Proposal for **amendments the proposed Interpretation
Document for: Regulation on uniform provisions concerning
the approval of vehicles with regards to software update and
software updates management system
(ECE/TRANS/WP.29/2020/80)**

**Submitted by the Informal Working Group on Cyber Security and
Over-The-Air issues**

ECE/TRANS/WP.29/GRVA/2020/29 was prepared by the Informal Working Group on Cyber Security and Over-the-Air issues.

3.3. The following flow diagram represents the process described above to enable software updates after registration.

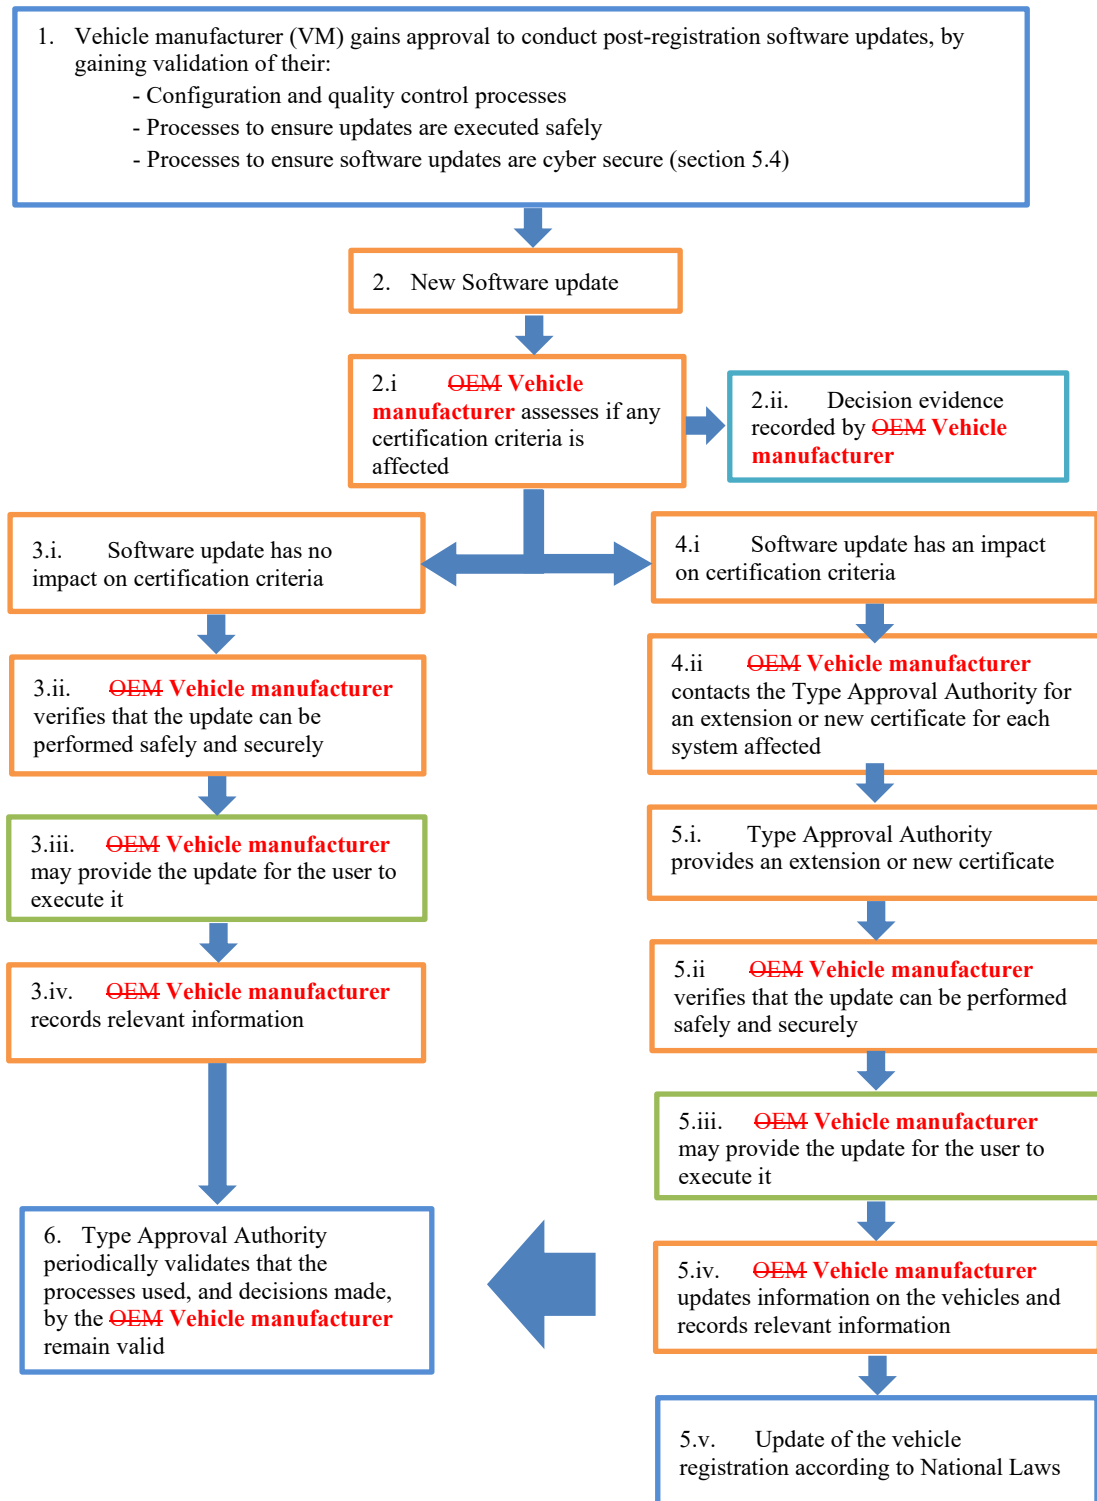
- 3.1. When a software update occurs after vehicle registration, including Over-The-Air (OTA) updates, the following steps may be employed when an update is under the control of the vehicle manufacturer:
 - (a) Before implementation of the first software update to a vehicle the vehicle manufacturer shall ensure it has a valid type approval for software update process **and** a valid Software Update Management System (SUMS) that is relevant to the vehicle type;
 - (b) The vehicle manufacturer shall assess whether a software update will directly or indirectly impact the compliance of the approvals of a vehicle's type approved systems and documents the result;

(c) If the update does not have impact on the compliance of any type approved systems, for example to fix software bugs, the vehicle manufacturer may conduct the update without need to contact the type approval authority but shall ensure the update process employed is safe and secure and that the changes related to the update are documented;

(d) If an update may or will impact the compliance of one or more type approved systems, then the vehicle manufacturer shall contact the relevant type approval authority to seek an extension or new certification for the affected systems;

(e) Where an extension or new certification is granted, registration of affected vehicles is conducted according to national laws. The update may then be conducted, and the vehicle manufacturer shall ensure the update process employed is safe and secure. The vehicle information in the Declaration of Conformance shall be updated after the installation of the new software to reflect the new type approval status of the whole vehicle type approval. The status of the software on a vehicle shall be updated to reflect the new status of its certification as per the requirements the software update process regulation;

(f) The type approval authority shall periodically validate that the processes used, and decisions made by the vehicle manufacturer were appropriate. The validation shall include an audit of a sample of the document(s) recording changes.
